SERVICE BULLETIN

M-1408

2014-2015 TOURING SADDLEBAG MOUNT - SAFETY RECALL 0166

Figure 1. Saddlebag Stud Receptacles

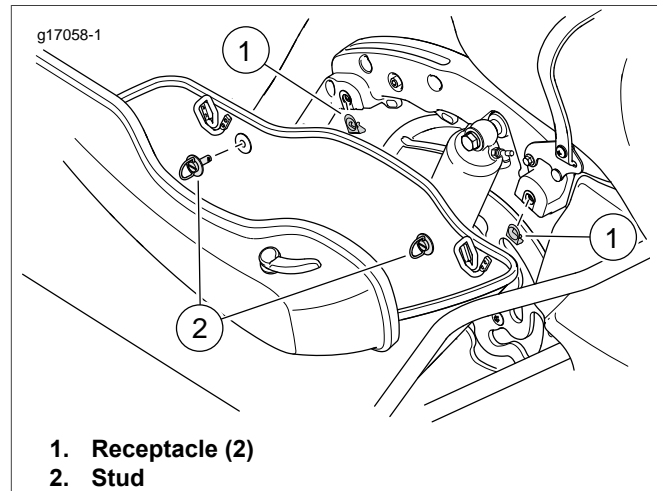
These model motorcycles built during the above date range may experience a failure of the saddlebag retaining receptacle. This may allow the mounting stud to disengage from the receptacle. If this condition remains undetected, the saddlebag may become separated from the motorcycle while it is in motion, possibly creating a hazard for other motorists.

- Kits required?: Yes.
- Kit wave shipments: Begin week of July 13, 2015 in limited quantities, which may require close usage management.
- Repair: All affected. No inspection required.
- Affected components: Part No. 10900009 Receptacle.
- Solution: Replace saddlebag receptacles.

1. Verify that the motorcycle is involved in this recall.
2. See Figure 1. Remove saddlebags.
3. Remove receptacles (1).
 - a. Insert a small screwdriver between receptacle clip and edge of saddlebag support.
 - b. Pry receptacle from saddlebag support.

4. Install **new** receptacles supplied in kit.
5. Install saddlebags using original studs (2) and washers.
6. When returning the motorcycle, remind the owner of the importance reading and following the saddlebag installation instructions provided in the owner's manual.
